# ITEM #2 - PRELIMINARY PLAT ROLLING HILLS SUBDIVISION ADDITION NO. 1 AMENDED SADLER ADDITION

KPB File No.	2025-115			
Plat Committee Meeting: August 25, 2025				
Applicant / Owner:	James Sadler – James Randahl Sadler / Sterling			
Surveyor:	Andrew Hamilton / McLane Consulting			
General Location: Montclair Cir and Nicholas St and Lou Morgan Road

#### STAFF REPORT

Aerial with 5-foot Contours

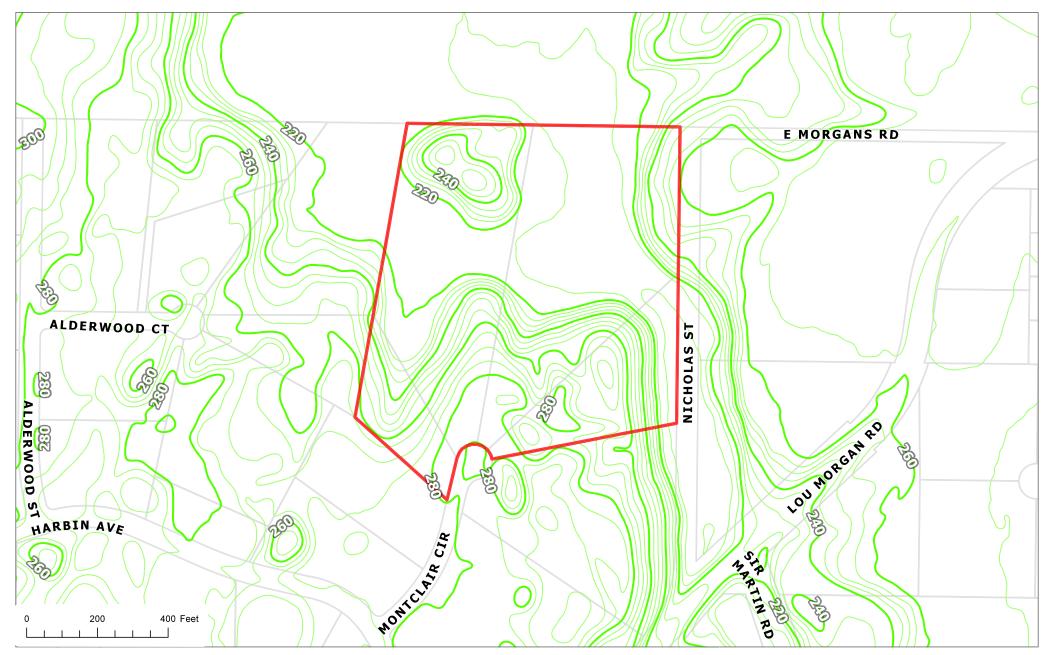
The Roads Director in his review of the plat noted East Morgan Rd should be extended west across to north end of the two lots or the plat. Per KPB 20.30.030 the plat should provide for the continuation or appropriate projection of all streets. *Staff recommends* the surveyor modify the drawing to include the extension of the half dedication of East Morgan Rd as a 30' dedication running to the west side of the plat as requested by the Roads Director. Additionally, include the standard plat note for road design and construction.

KPB records indicate the section line easement may be along the north boundary may be 50-feet wide. **Staff recommends** the surveyor verify the easement width and modify the section line easement label on the plat if needed.

The River Center Review identified the plat to be located in a FEMA identified Flood Hazard Area of Zone X-unshaded. The note in KPB 20.30.280(D) should be added to the plat notes, including the FEMA Firm Panel and Flood Zone designation.

**Staff recommends** the former line between lots 4a and 5A be dimensioned for purposes of identifying the setback and easement limits. Add a label for the 20-foot building setback.

HEA has requested the easement as shown on KN87-84 along the southwest line of Lot 4B be added to the drawing. HEA comment is included in the packet.

Modify KPB File No to 2025-115

Add Block 2 to the legal description of the parent plat.

Label Hall Lake

Add Block 2 to the lot numbers
